CHANGES FROM BASE PRODUCT VBV-L4025 (1554) TO AC-042 (4246)

Assembly PI Approval		Approved by		Checked by		Drawn by	
JFULLER - 12/06/13		GPLTH		BCHLDS		MPOTTER	
Angle of Projection		Units		Scale		Released	
Third Angle		mm		N/A		13/06/13	
Status		Released		AC-042		Assembly Ref	
Part No		4246		BE-002200-00-12		-

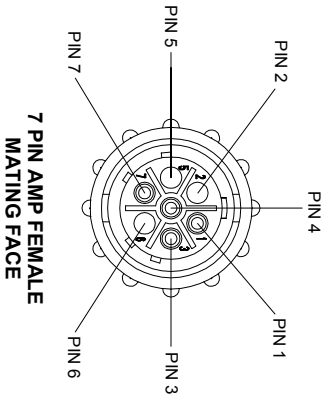
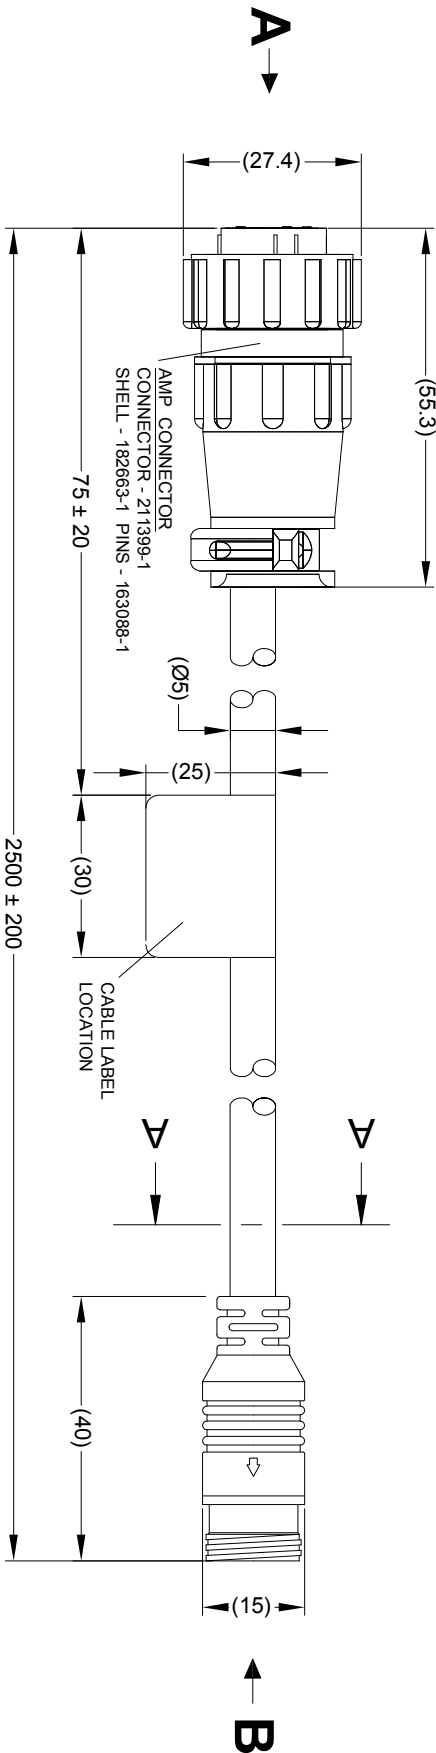
1. REPLACE 4 PIN FEMALE CONNECTOR WITH 7 PIN FEMALE AMP CONNECTOR.
2. REPLACE VBV-L4025 CBL-LBL WITH AC-042 (4246) CBL-LBL.
3. REPLACE VBV-L4025 GB-LBL WITH AC-042 (4246) GB-LBL.
4. PROTECTIVE BOOT REMOVED.
